RE: **Project Name:** BAAF 47431 Hangar 4 Roof and Envelope Project
 Project Number: 02A7026004
 Project Location: JBER, Alaska

Addendum # eight
(8)

PROJECT RENOVATE HANGAR DOORS BRYANT ARMY AIRFIELD ANCHORAGE, AK CONTRACT # 99-1280-03-0-0003-0029 (Mod 15)			
CONTRACTOR H. WATT & SCOTT, INC. 10360 High Road Anchorage, AK 99515	DESIGN STEVE SPENCER	JOB NO CC2421	HANGAR 4
		ELEVATION	09-17-13
		ASBUILT DRAWING	NO - 002

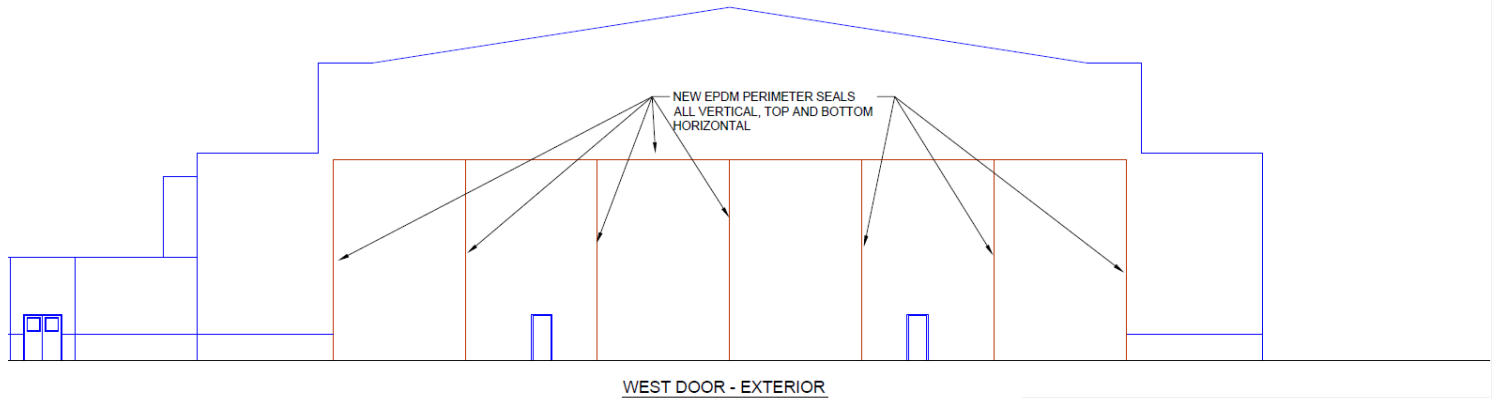
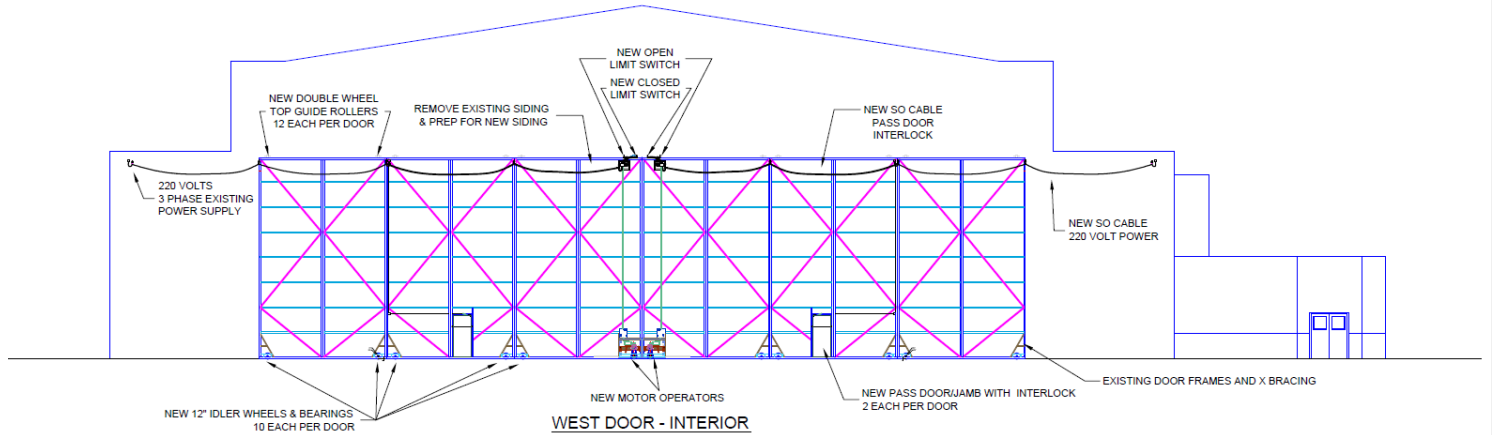
10. Q: Please confirm: (a) whether the base bid hazardous materials survey is to include a lead determination on the hangar door coating and on the exterior siding coating, and whether that determination must be complete before surface preparation begins; (b) if the determination returns positive, whether the Department accepts that the doors will be unavailable while regulated containment is in place, and how the 50 percent usability requirement is then satisfied; (c) whether the schedule effect of a positive determination is handled as a change to the contract under the same mechanism Addendum No. 5 Question 4 applies to abatement cost; and (d) whether the Department holds any prior lead survey, coating record or maintenance record for the hangar doors that will be made available to bidders.

A: In 2013 the hangar door siding was replaced with new during the Hangar Bay Door Refurbishing Project. Attached below to this addendum.
